RE: Meeting with Summit Township Supervisors
Special Study
Kearsarge Pump Station

MTSA - KEARSARGE PUMP STATION
OVERFLOW RETENTION FACILITY (ORF)

Re: Kearsarge Pump Station Special Study-Draft
Review

COMMENTS & RESPONSES

Figure XI-a

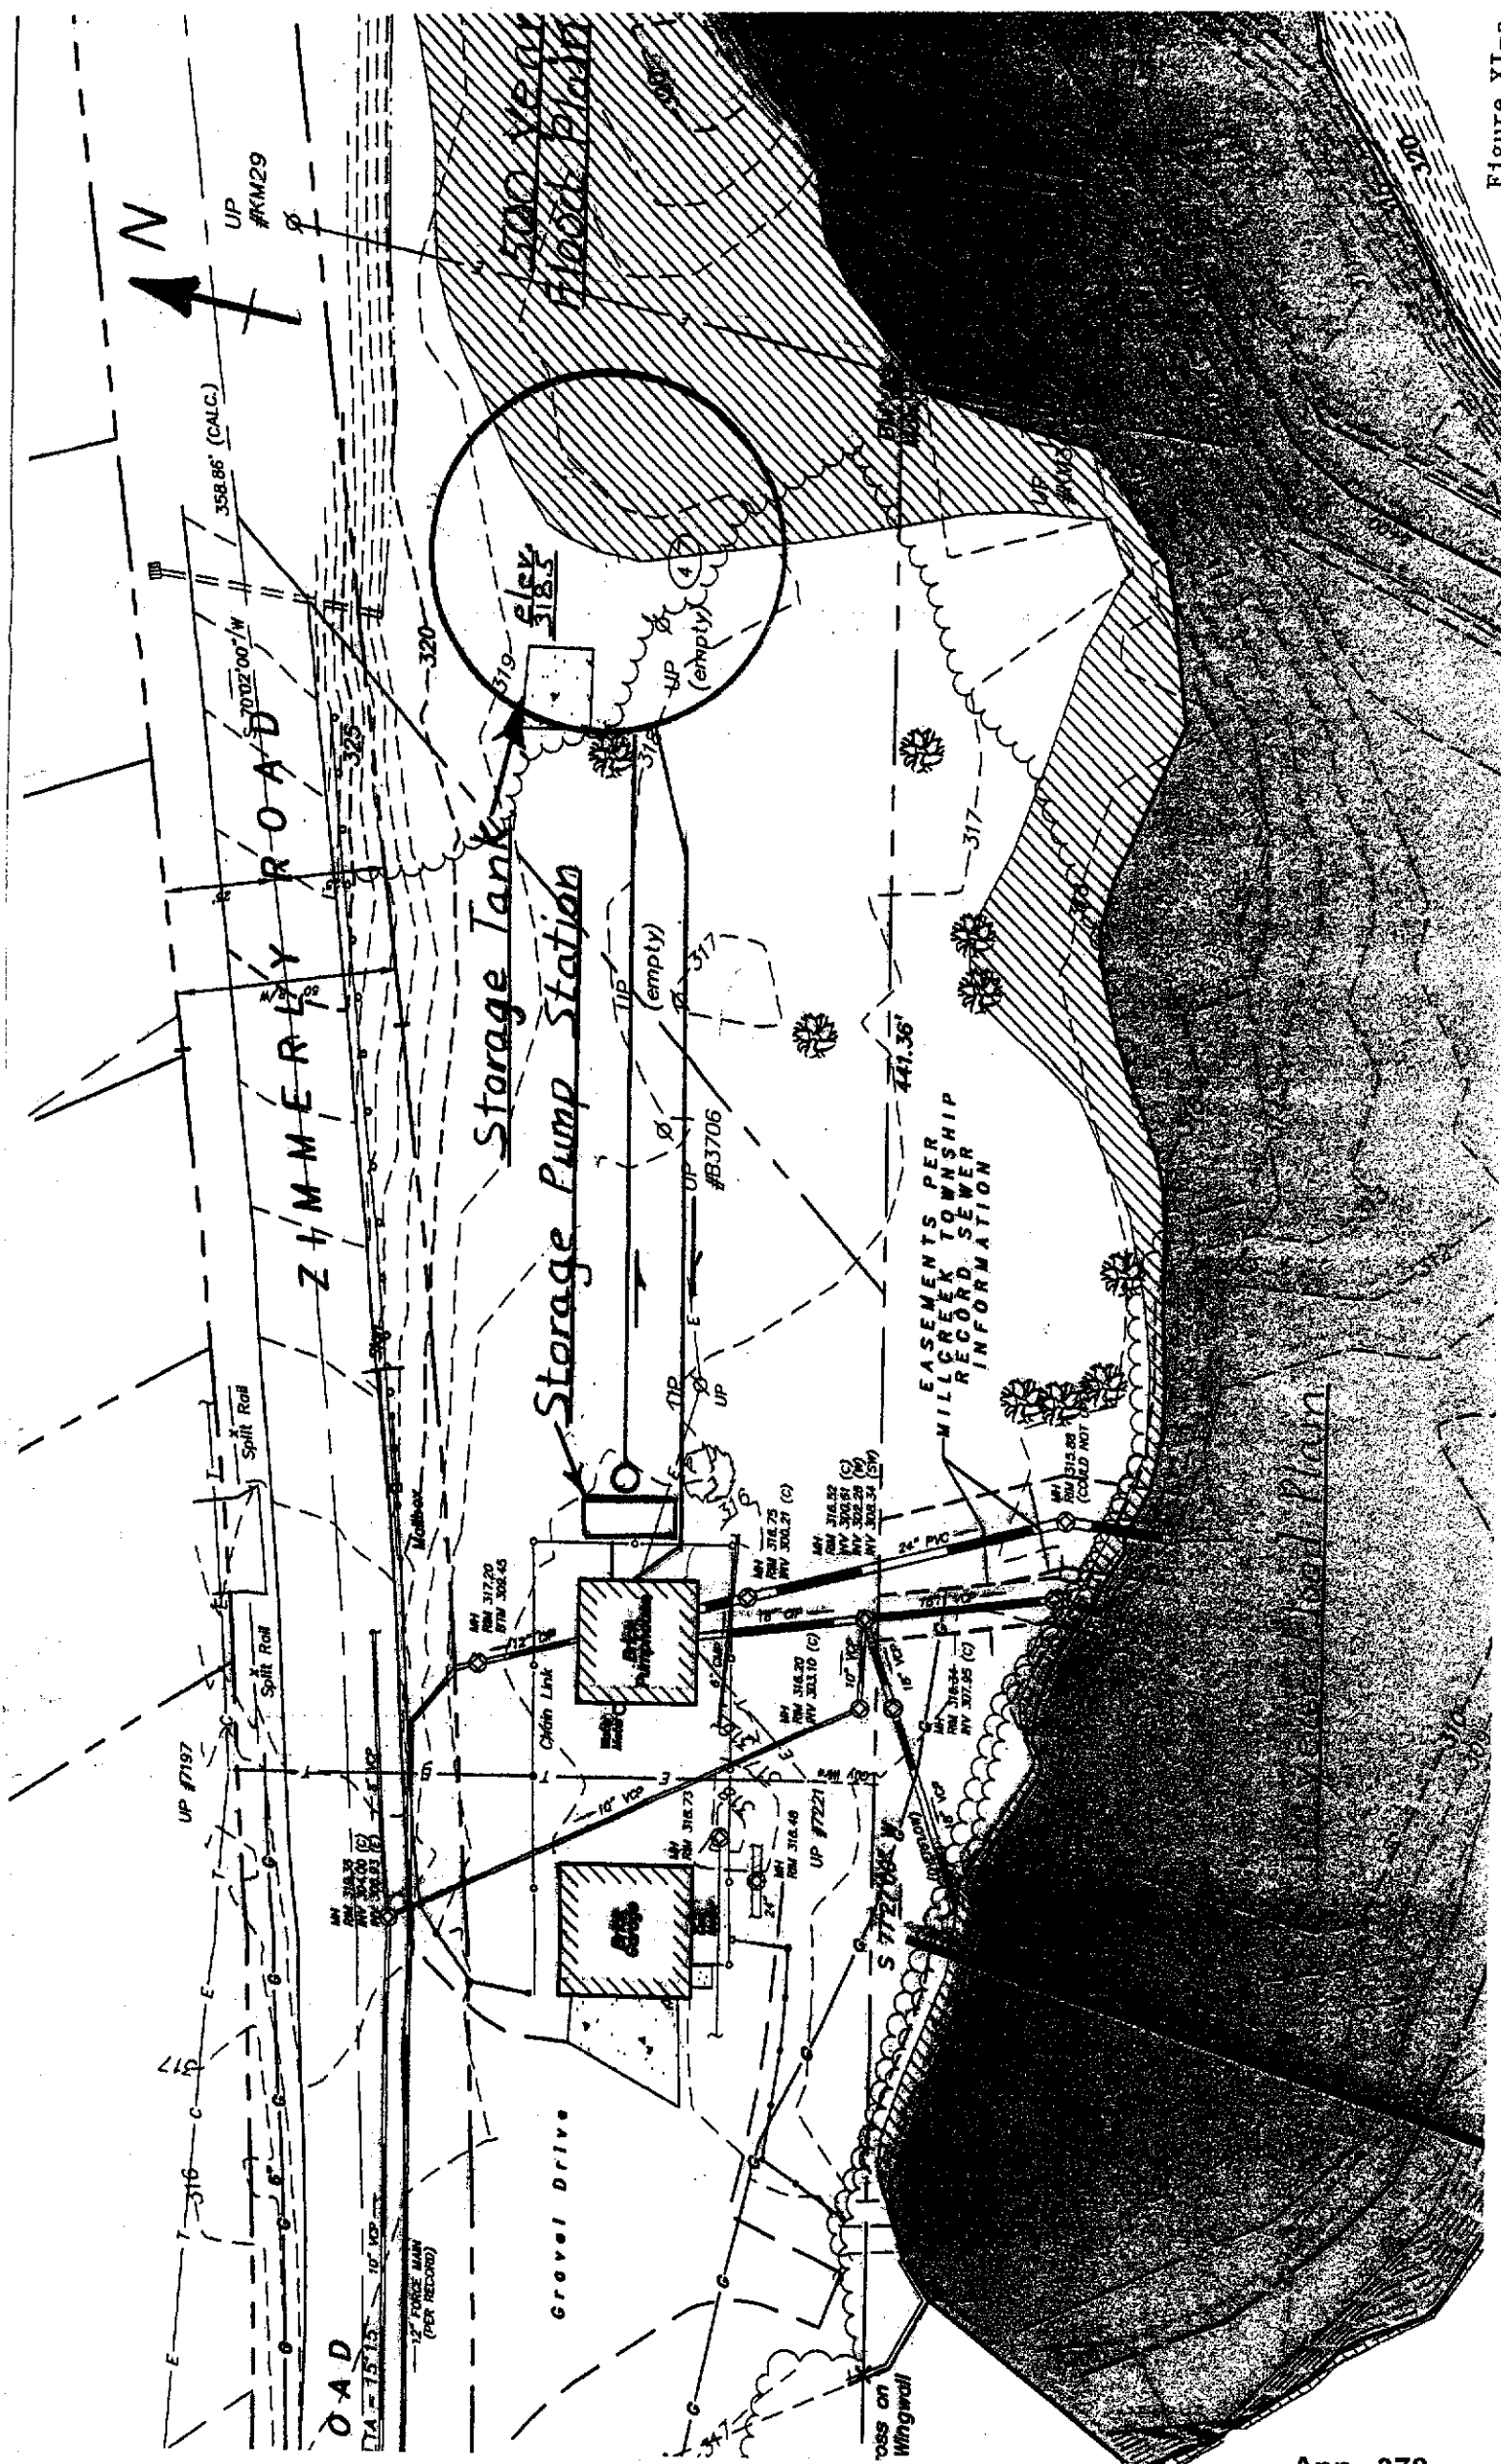
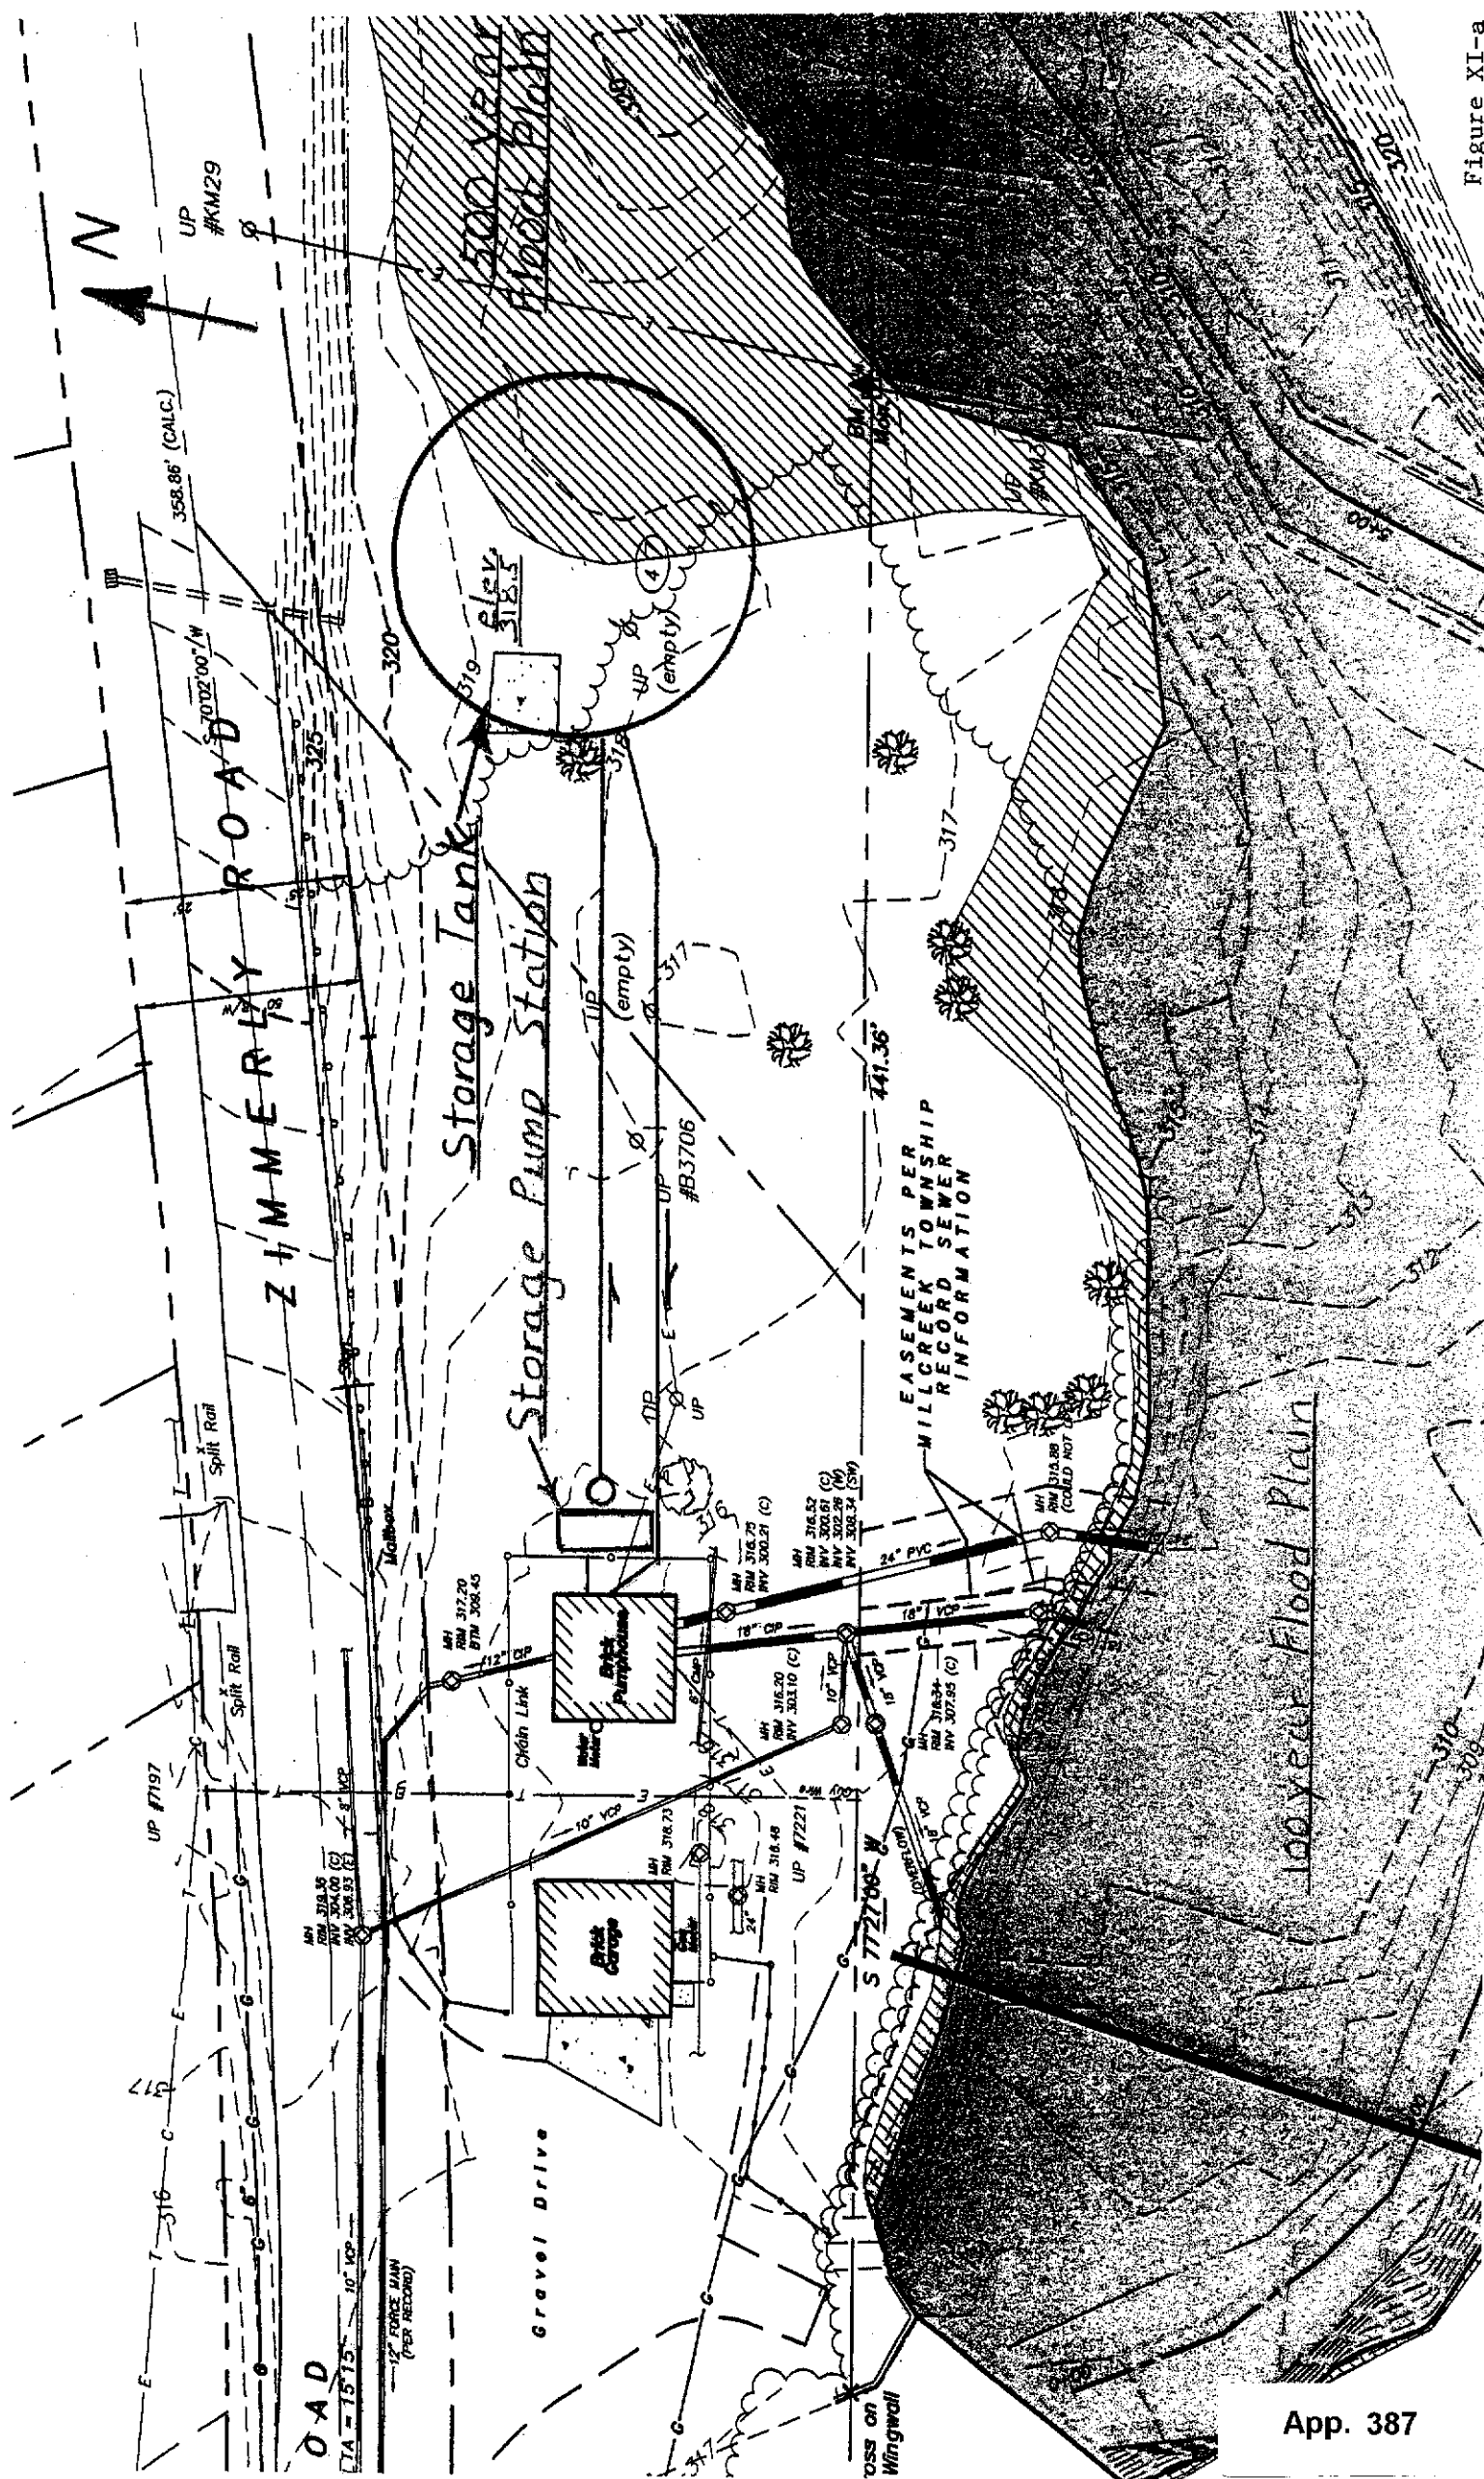
- b. Under the last bullet of the schedule, change "Abandon" to "Remove overflow and eliminate overflow events tributary to Kearsarge Pump Station."
- 2) Please provide a site-level planning map depicting the location of the proposed storage tank and any anticipated floodplain or wetland encroachments.

- a. Implementation Schedule Wording Changes?
Changes made on page 3.
- b. Site Level Planning Map?
Figure XI-a

FIGURE x-e

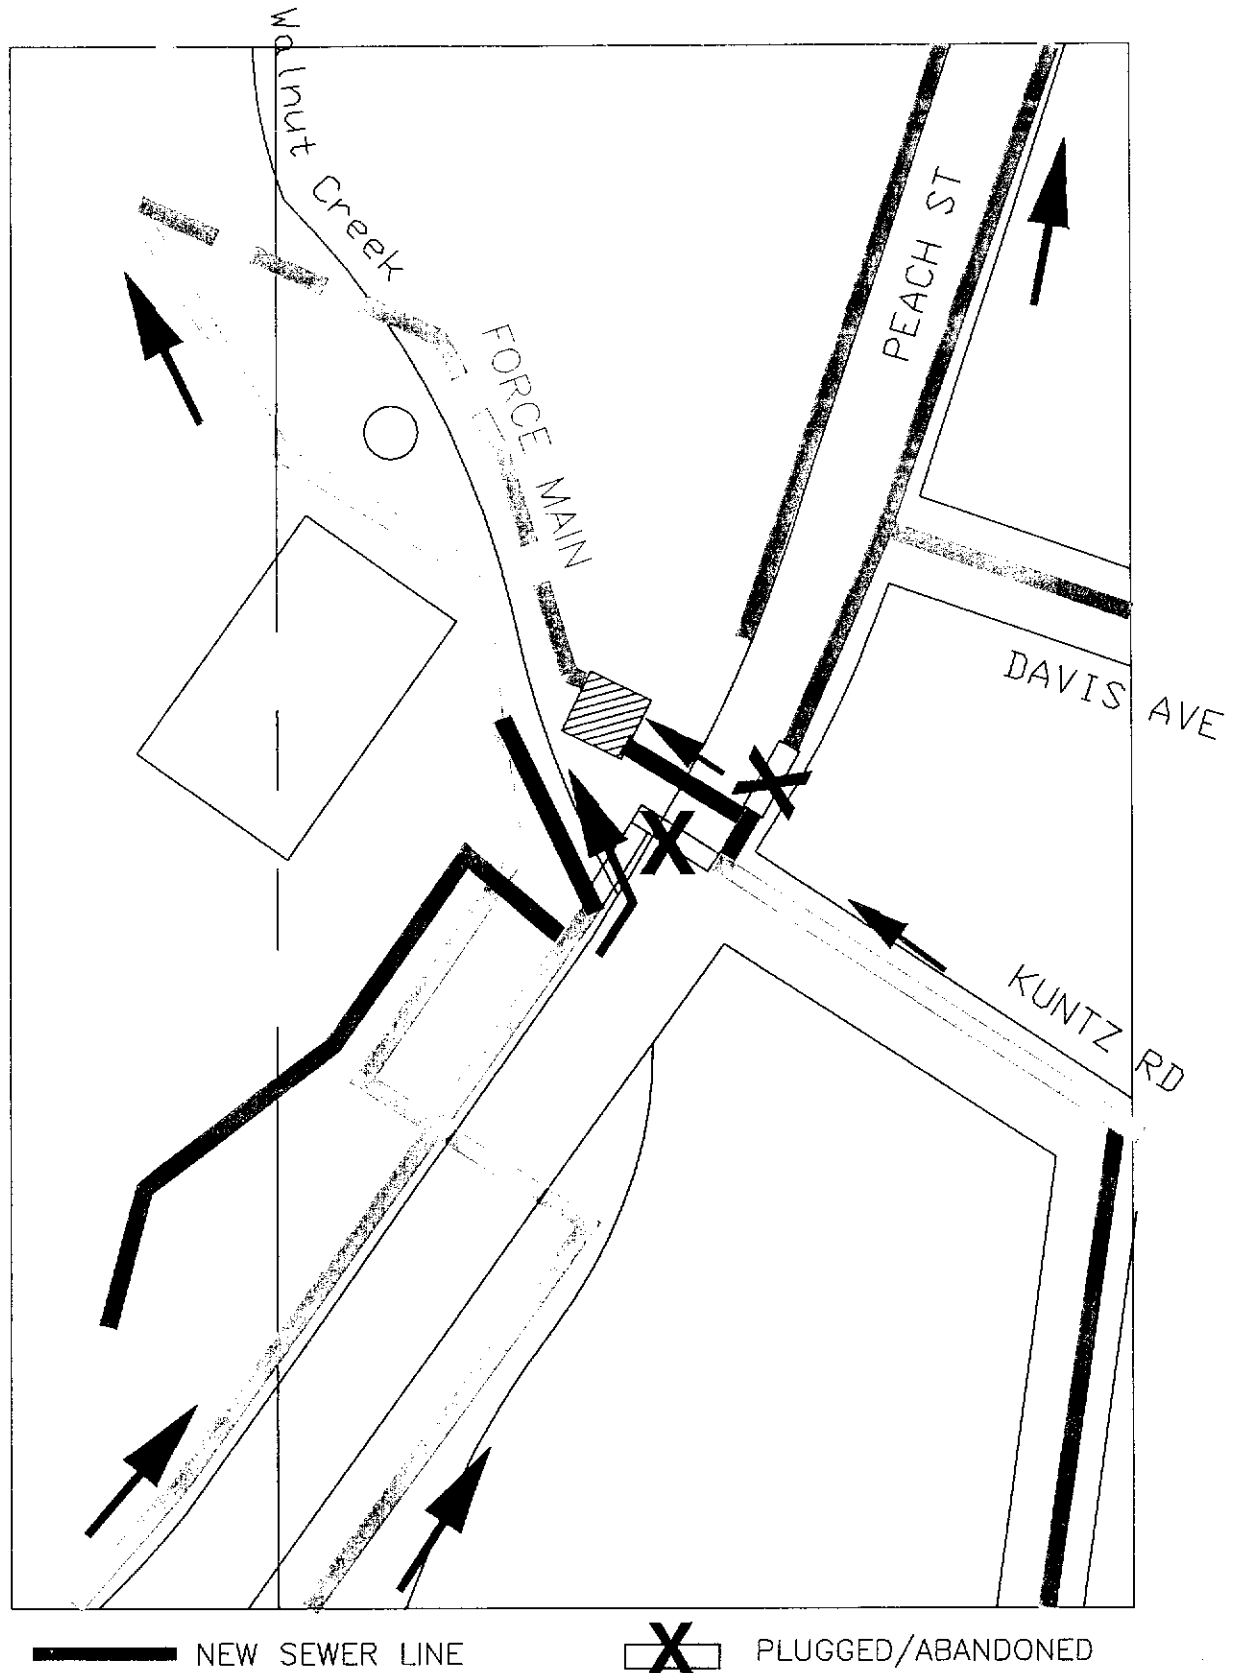
- 3) Figure I-a depicts the location of the proposed interceptor diversions. Without possessing knowledge of the locations of the existing sewer lines, this figure is difficult to interpret. Please modify, or provide an additional map that illustrates the direction of sewage flow before and after the proposed diversions.

- c. Better Description of Areas of Sewer Rehab and Proposed Changes?
Figure SI-a / VIII-d has been modified and Figures X-e, X-f, and X-g added to describe proposed changes.
- d. Study of Back Water Valve Needs Not Included?
Appendix volume included.
- e. Include Costs of Back Water Valves and Sewer Rehab?
Included in new Appendix A-4.
- f. Preface Storage Flow Wrong?
Changed.
- g. Summit Responses Concerning Study Recommendations?
Included in new Appendix A-1 and A-2.
- h. Address all items under 25 PA Code Section 71.31?
Yes
- i. Include Narrative on Removing Overflow without Spillage in Permit Application?
A suggested paragraph is included in new Appendix A-5.
